SERVICE LETTER

No. 627

Piper Aircraft Corporation

Propeller Installation

Service Letter 627

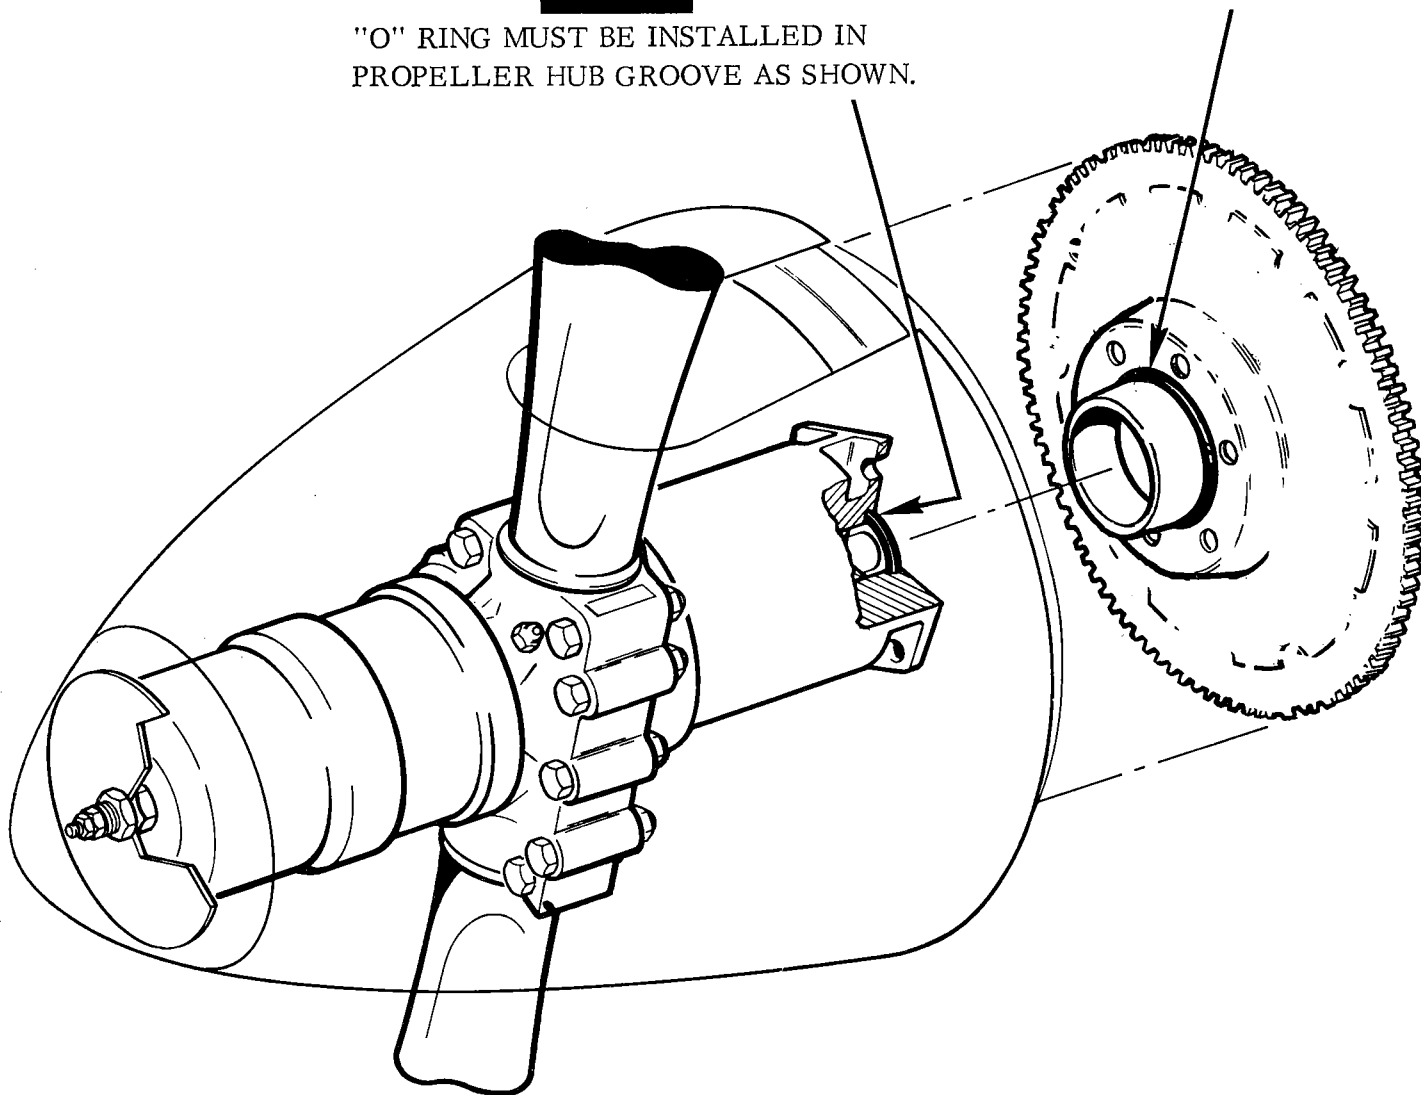
next fifteen hours of operation, loosen the propeller mounting bolts and slide the propellers forward on the shaft so that the area between the prop flange and the engine crankshaft flange is exposed to view. Visually check to insure that no "o" ring is installed on the shaft in this area.

A. If an "o" ring exists in this location, the "o" ring must be discarded and the propeller should be removed from the aircraft and inspected to insure that the proper "o" ring is correctly installed in the propeller hub groove -- as shown in attached sketch.

"O" RING MUST BE INSTALLED IN
PROPELLER HUB GROOVE AS SHOWN.

DO NOT INSTALL "O" RING
OVER CRANKSHAFT FLANGE.

3. Reinstall propeller, insuring that prop mounting bolts are properly torqued.
4. Make appropriate log book entry.
